## Development Review Committee

**TO: Howey-in-the-Hills Development Review Committee**  
**CC: J. Brock, Town Clerk**  
**FROM: Thomas Harowski, AICP, Planning Consultant**  
**SUBJECT: Lake Hills Residential Preliminary Subdivision Plan**  
**DATE: November 28, 2023**

December 11, 2023  
Lake Hills Preliminary Subdivision Plan  
Engineering Review Comments  
Page 1

**TO:** Howey-in-the-Hills Development Review Committee  
**CC:** J. Brock, Town Clerk  
**FROM:** Thomas Harowski, AICP, Planning Consultant  
**SUBJECT:** Lake Hills Commercial Preliminary Site Plan  
**DATE:** December 6, 2023

IMPROVEMENT PLAN

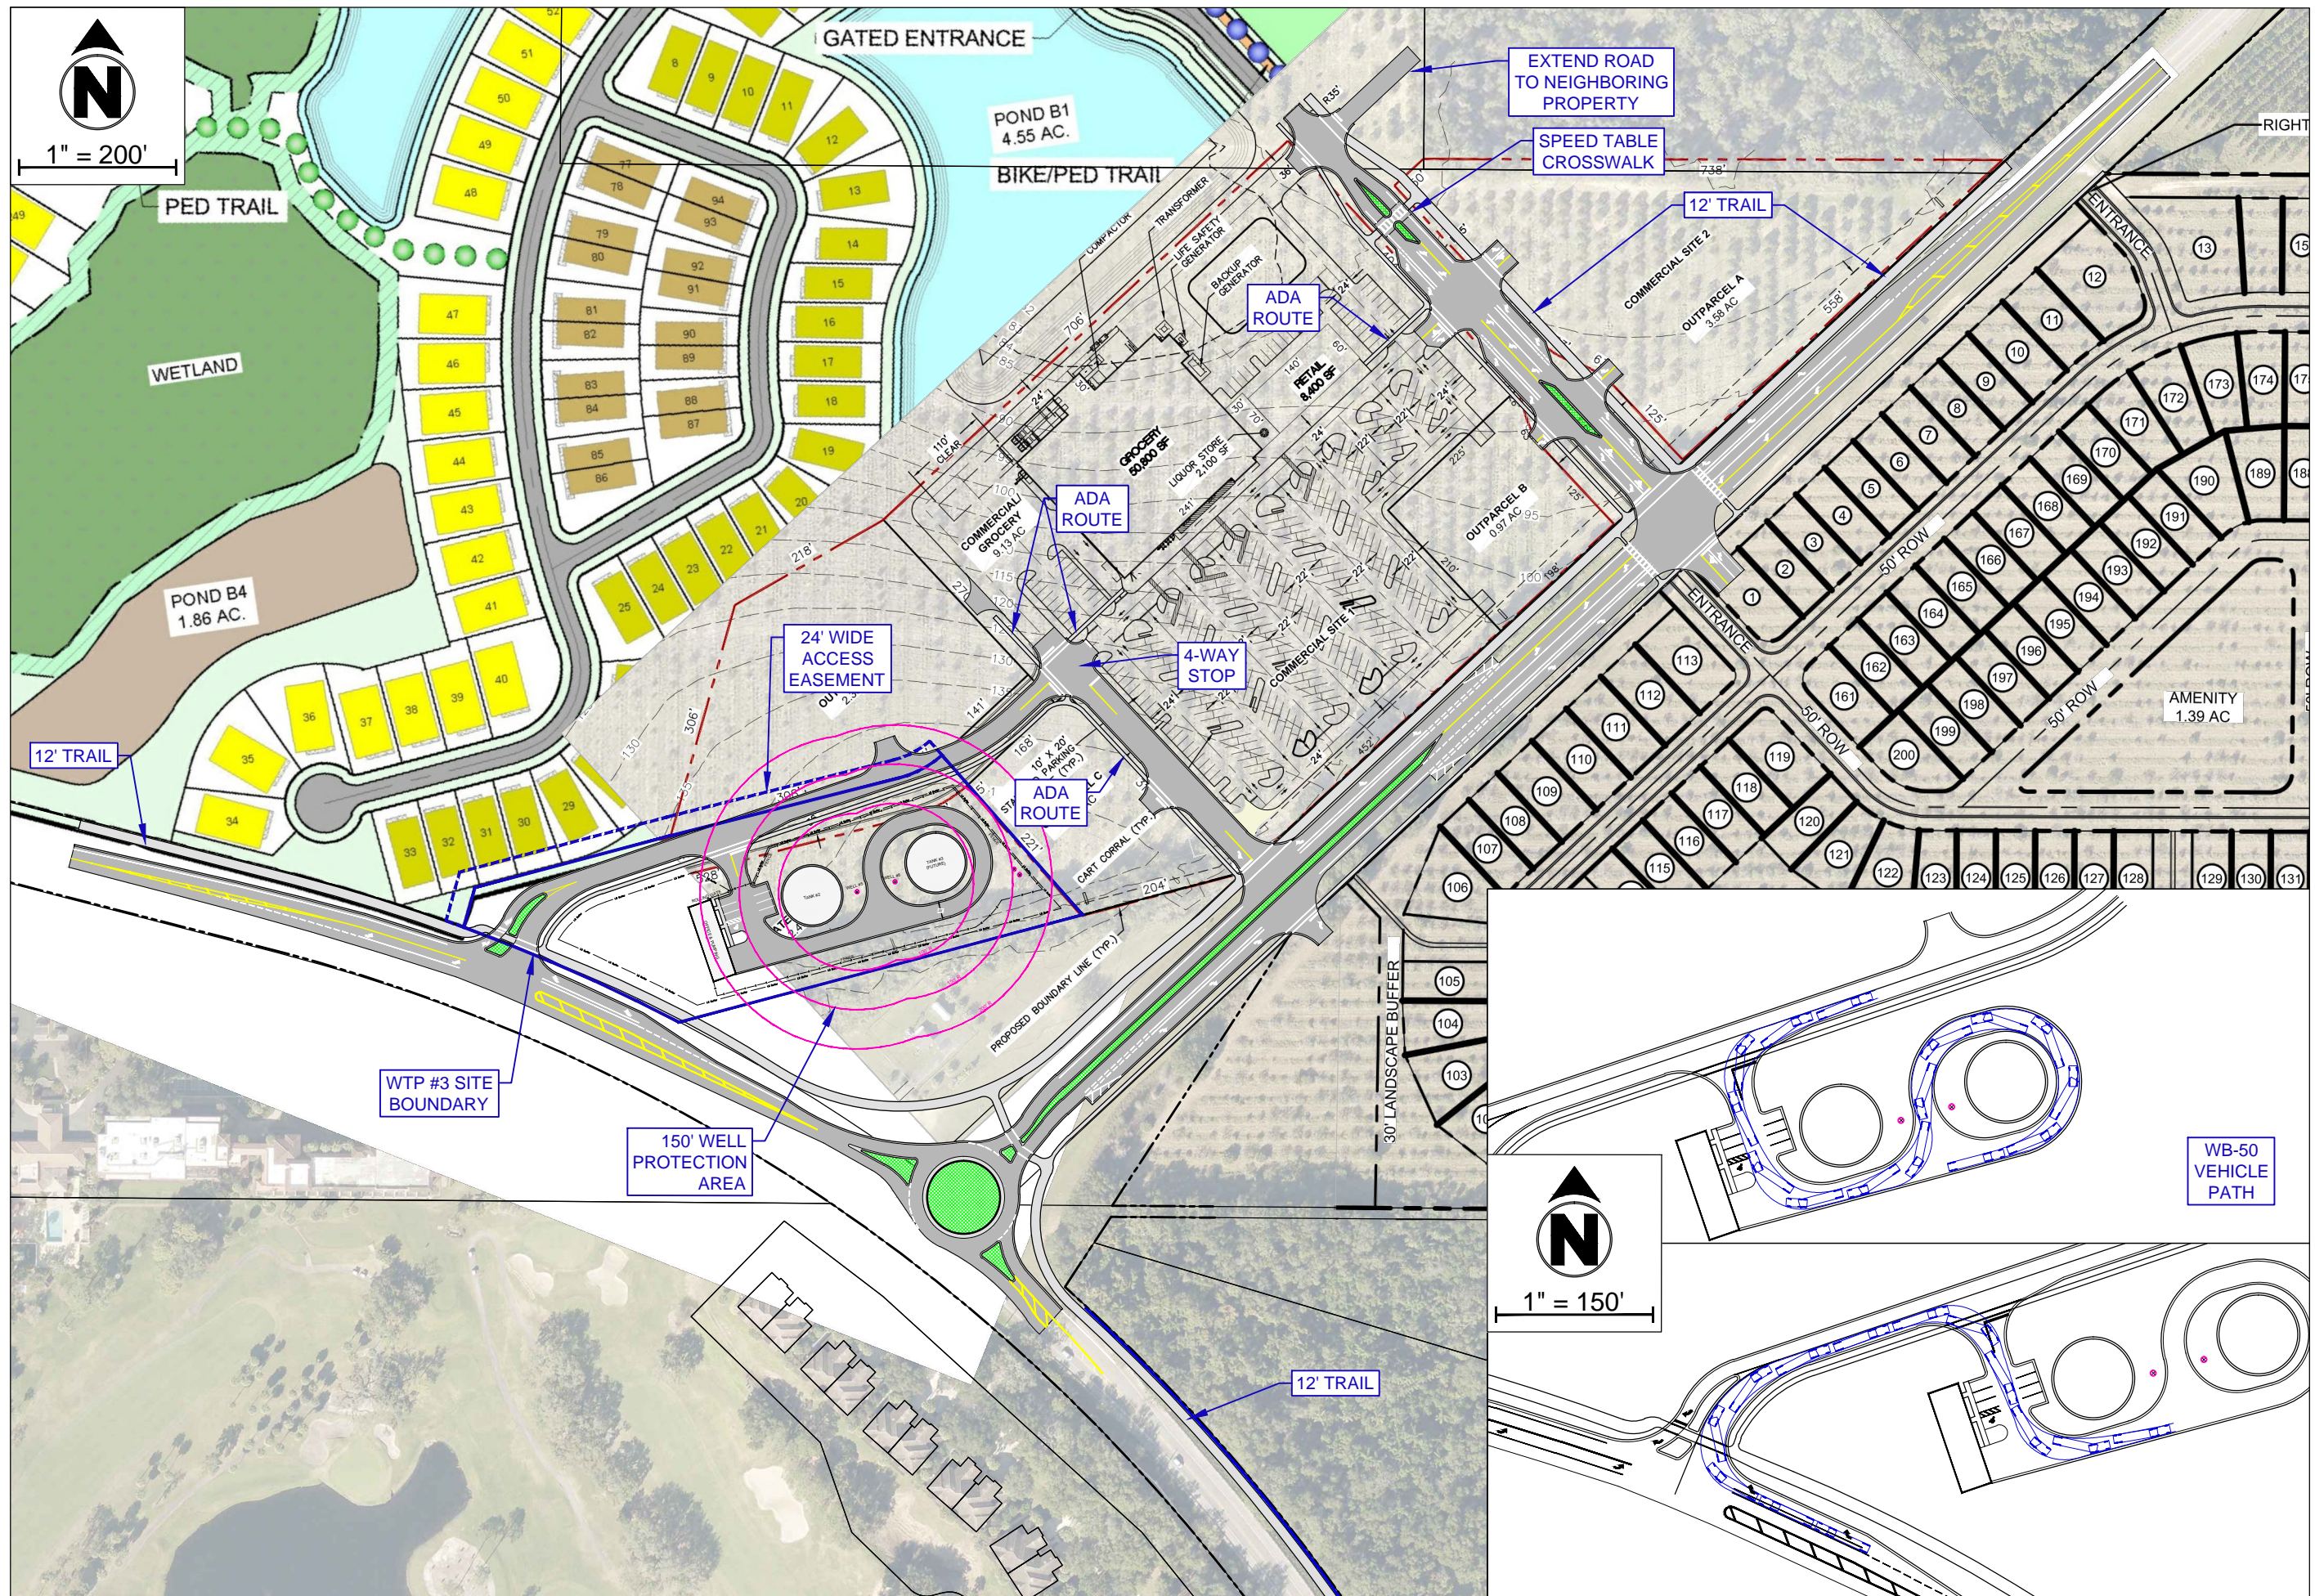
Revise the plan to incorporate the modifications to the SR 19 entrance road shown in the SR 19 & CR 48 Improvement Plan including turn lanes, sidewalks, trails, and traffic control. Widen the proposed right-of-way as needed to accommodate the improvements.

Include a road stub out at the south end of the Public Park to provide access to the neighboring property to the east. This should also be the park's access drive.

NOTE:  
PAIRED HOME LOT - 4,800 SF MIN. LOT SIZE. 90% LOT COVERAGE MAX. FRONT GARAGE.  
**PAIRED HOME LOTS**

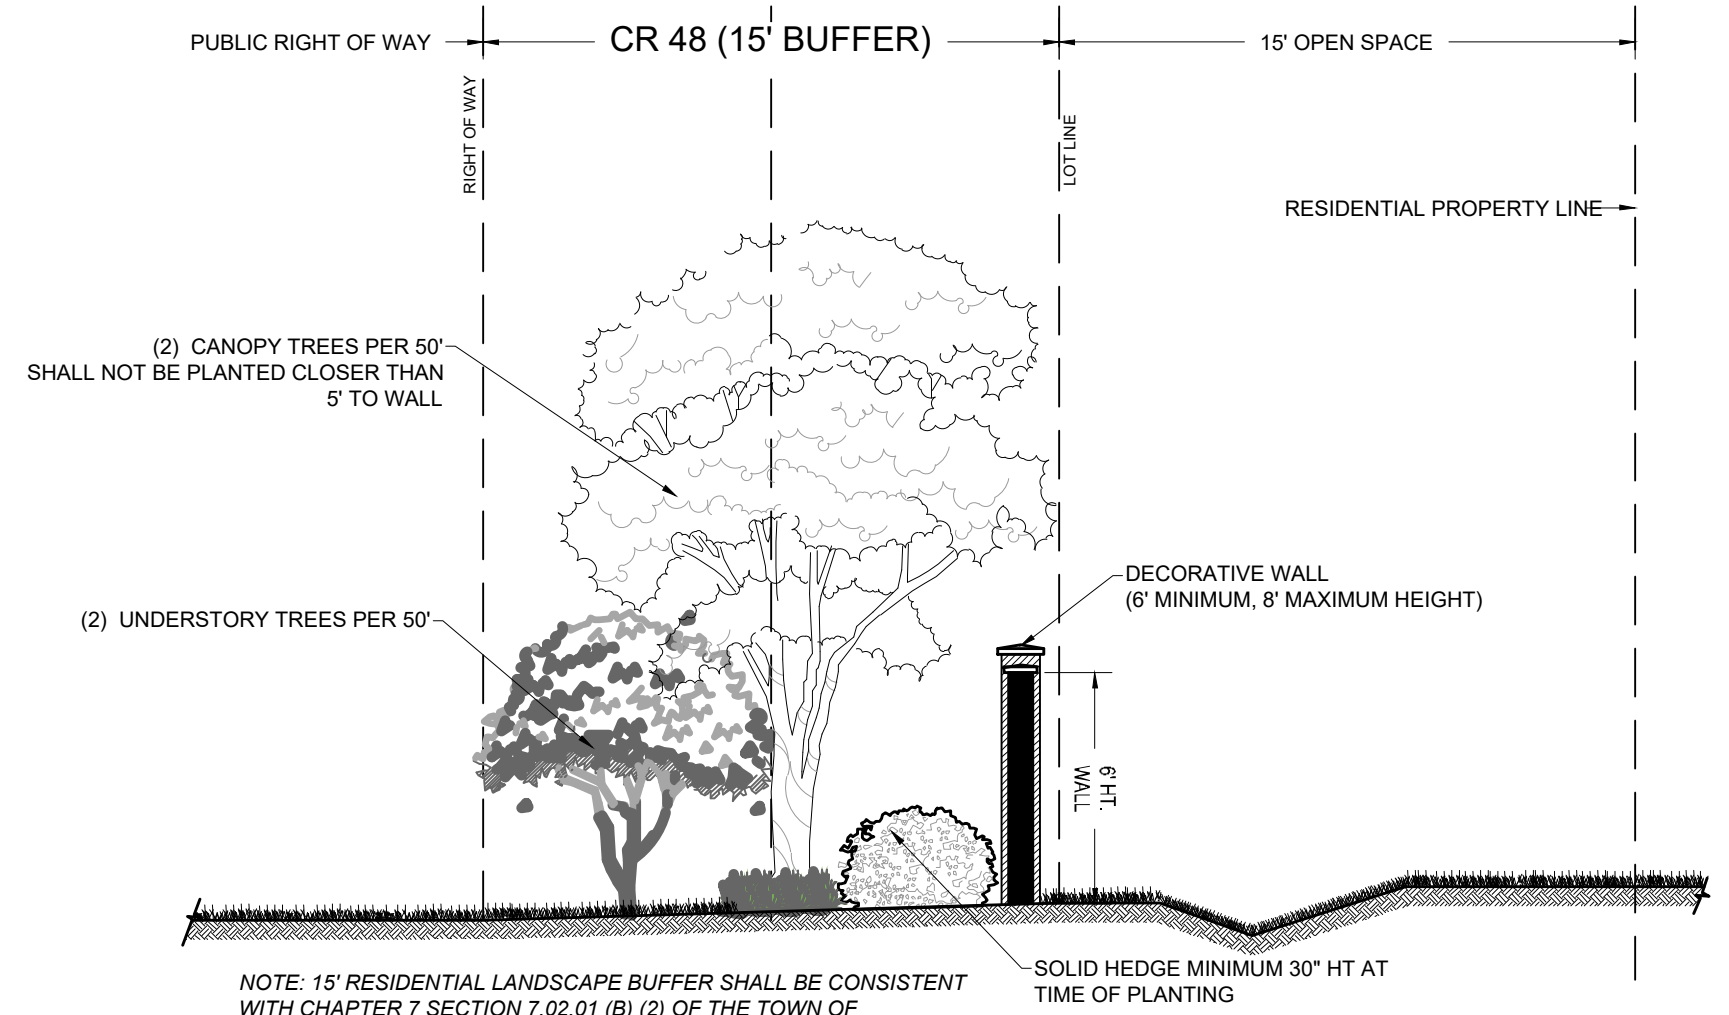
- The detail for the paired home requirements is incorrect. The development agreement requires the paired homes to be served by alley access. Alleys should be a simple addition to the design as presented.

**LB15**  
TYPICAL - CR 48 (15' BUFFER)  
N.T.S.

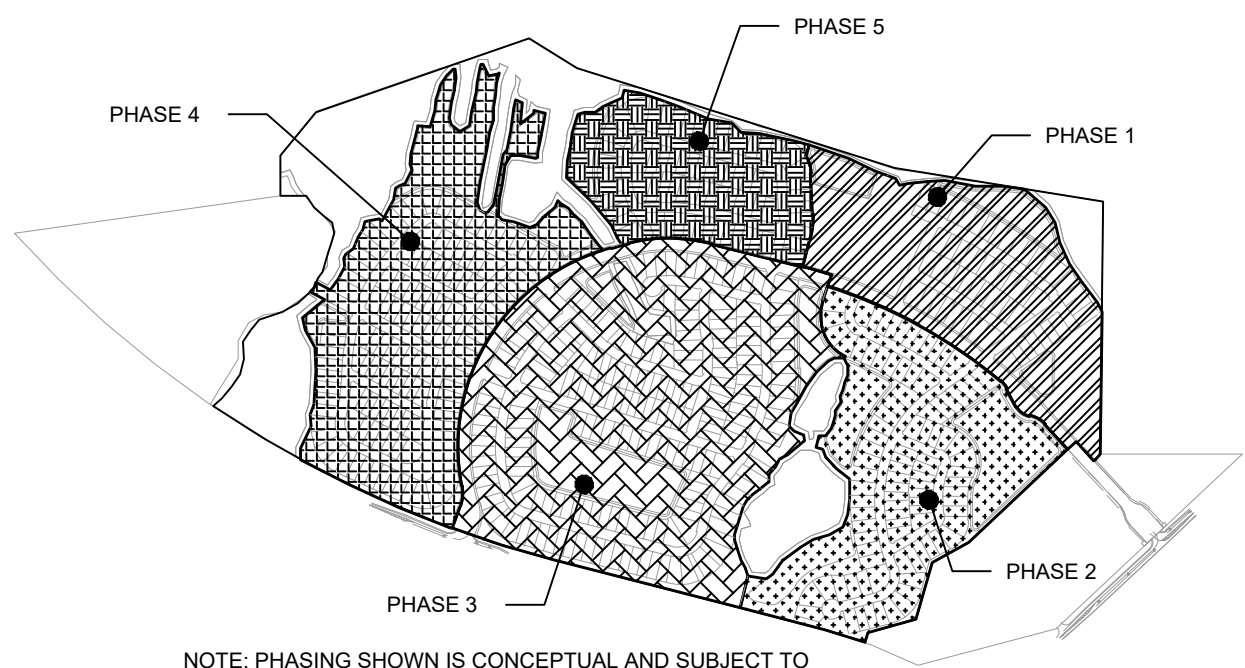
- A connection from the project to the commercial access drive needs to be considered for the adjacent residential area.
- The buffer detail for CR 48 includes a buffer area to the inside of the screening wall required by Town code. This area should be landscaped. Additional shade tree plantings in this area will add significant depth to the screening.

IMPROVEMENT PLAN

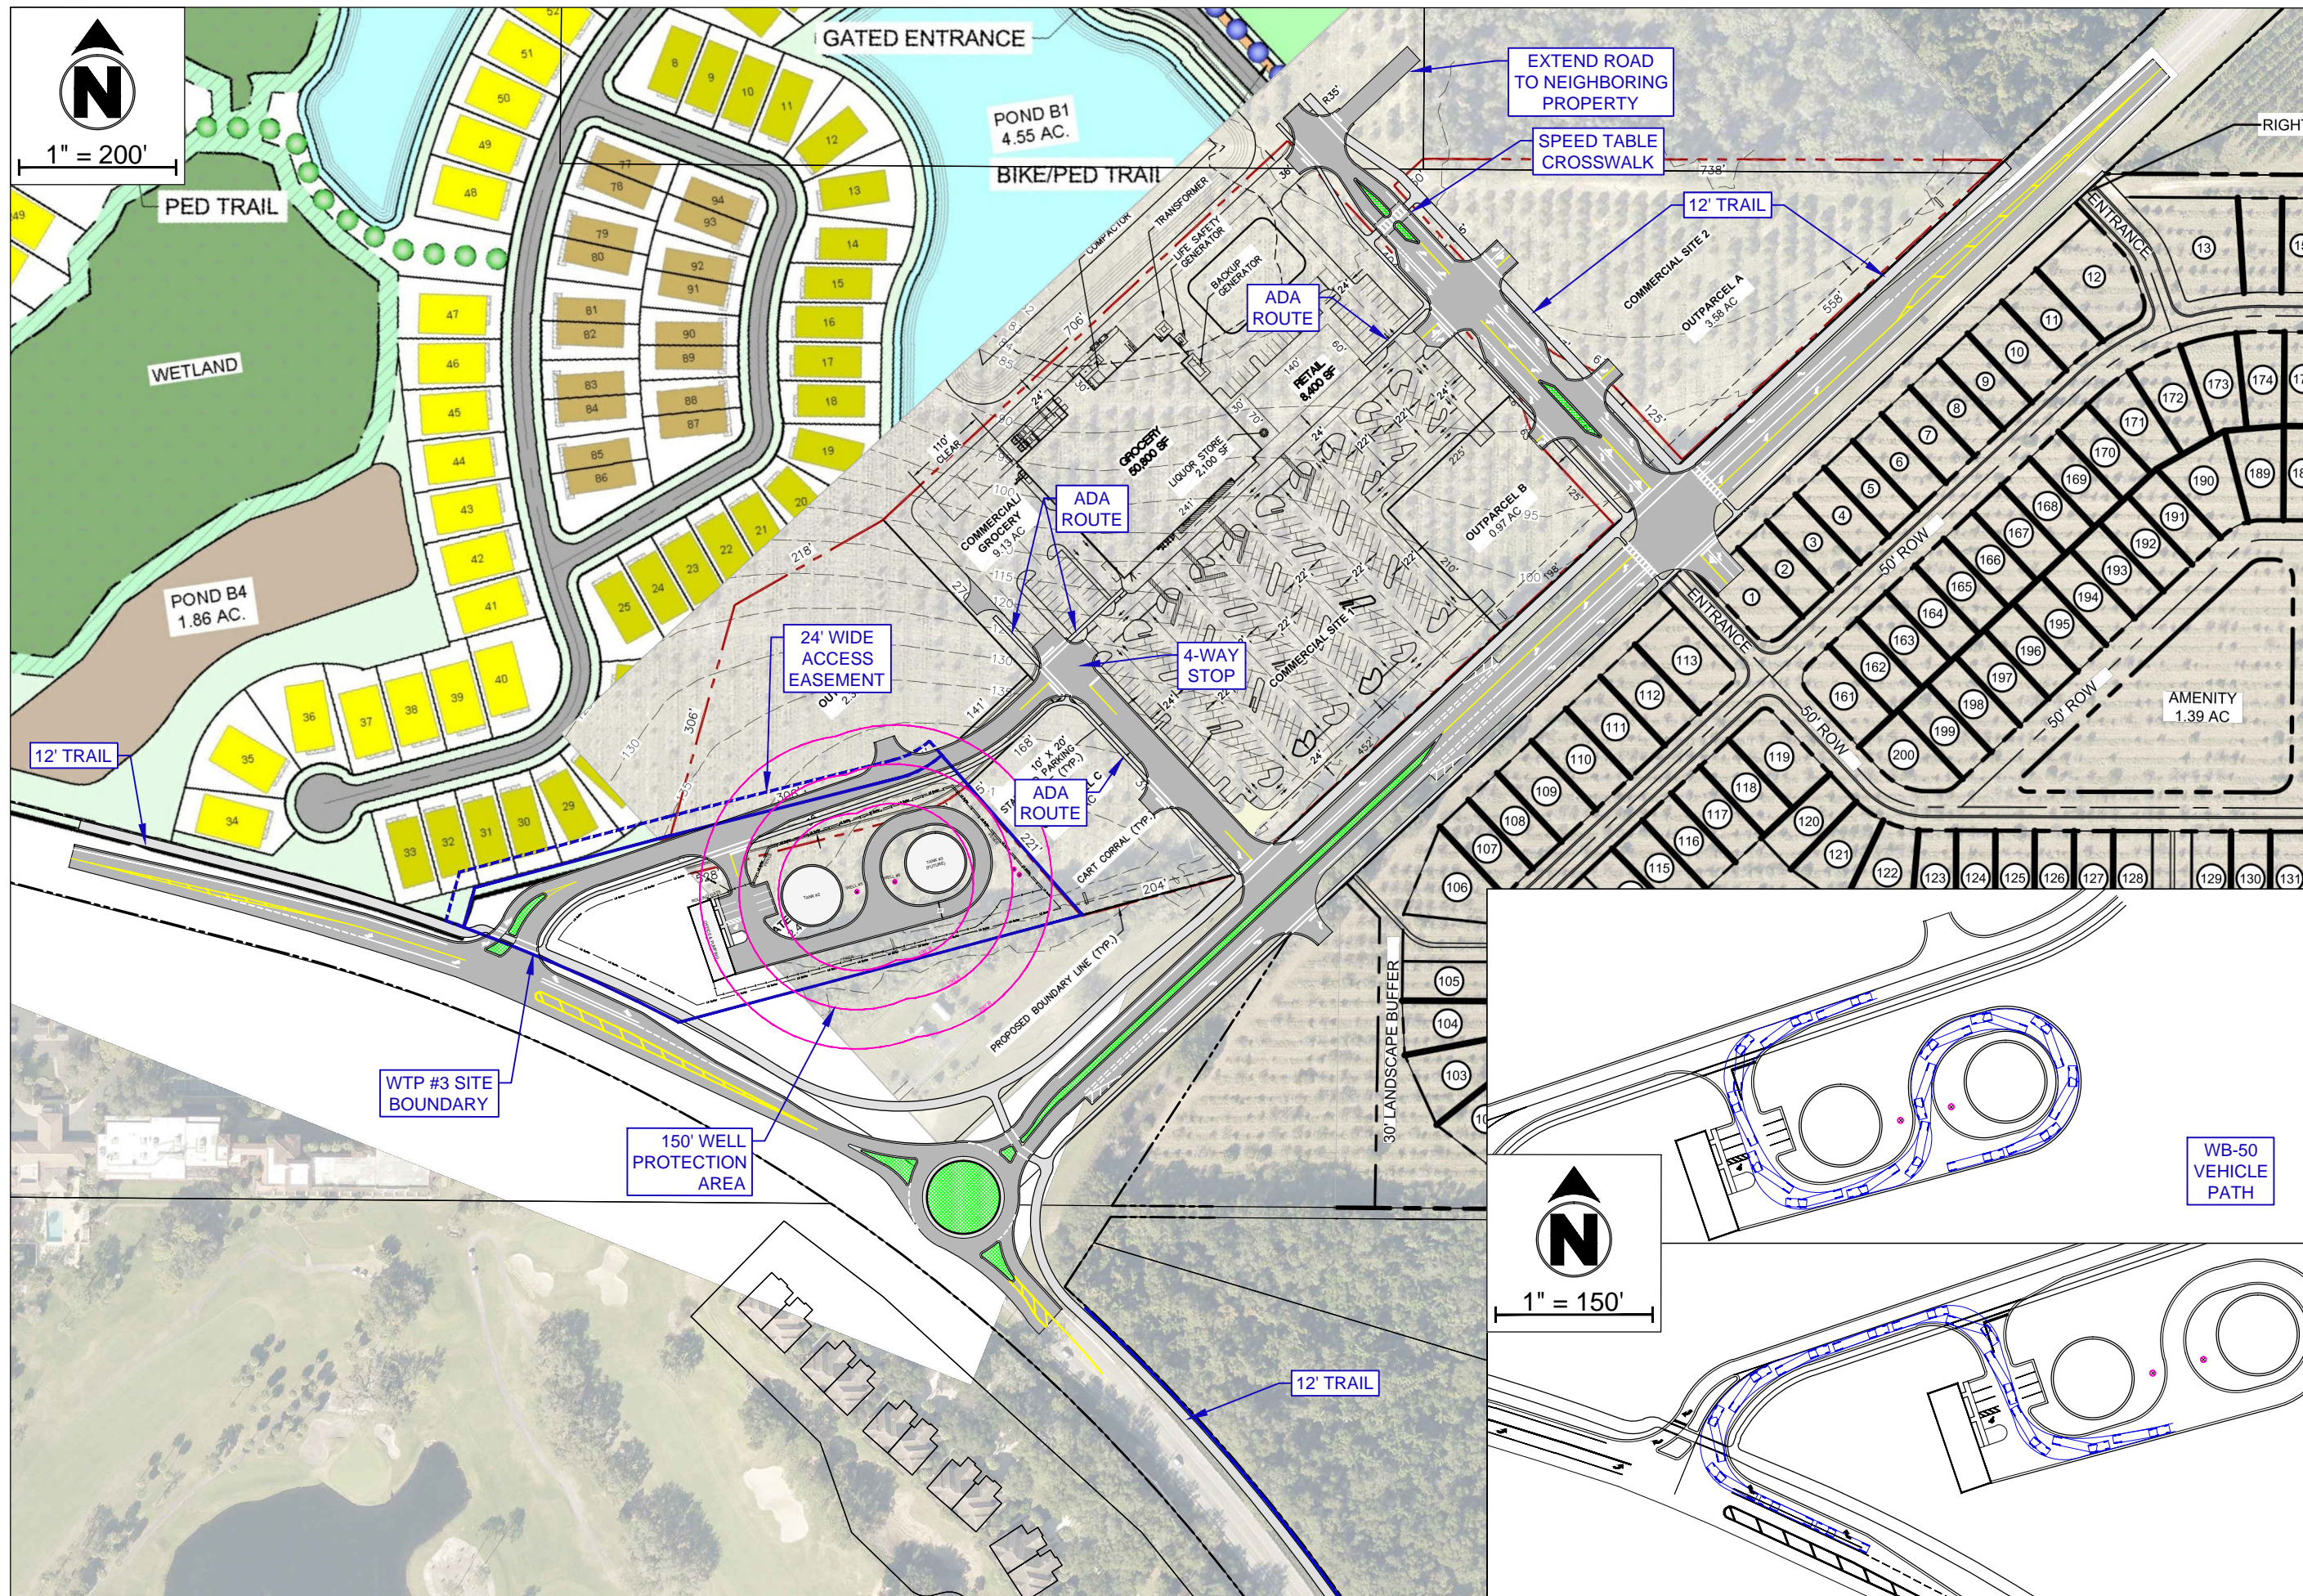
Revise the site plan to incorporate the modifications shown in the SR 19 & CR 48 Improvement Plan including turn lanes, sidewalks, trails, traffic control and ADA routes.
